ADDENDUM # 2
9/21/2020

RFP# 7608807

TITLE: Decommissioning Services Alternate Hospital Sites (RICC)

RFP# 7608807 – ADDENDUM #2

A1 3rd FLOOR PLAN - AREAS OF CARPET, STEAM-CLEANING
SCALE: 1/8" = 1'-0"

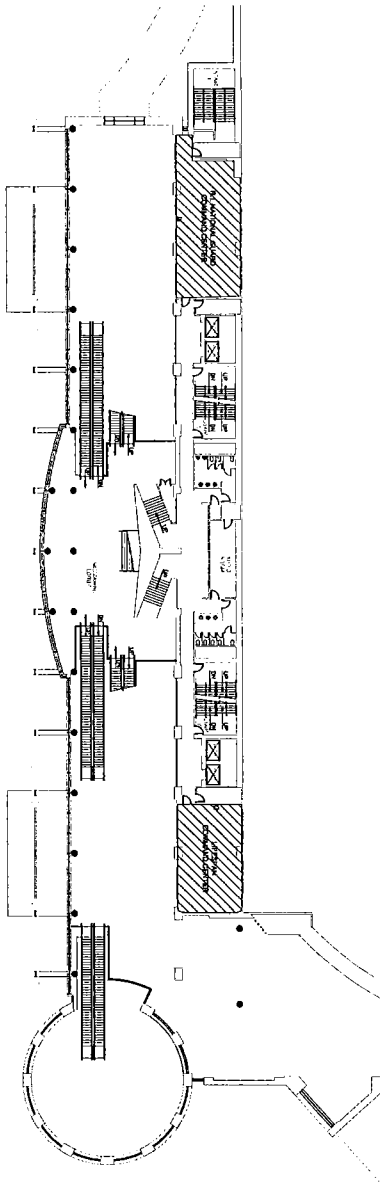
21. On A-112, Partial 5th floor plan in Ballroom A there is the note, "Contractor shall have full carpet steam cleaned in all areas of AHS project work". Please clarify which rooms need carpet steam cleaned as steam cleaning the entire building would be very expensive.

DEDUCT ALTERNATE No 1 – Vacuuming instead of Steam-Cleaning the Carpets in Areas of Construction

DESCRIPTION OF ALTERNATE: See Addendum 2, SKA-01 & SKA-02 for extent of carpet to vacuum-clean instead of steam-clean.

Answer: See item 18 on Addendum 2, Part 3-Revisions/Modifications to RFP #7608807 regarding carpet steam-cleaning.
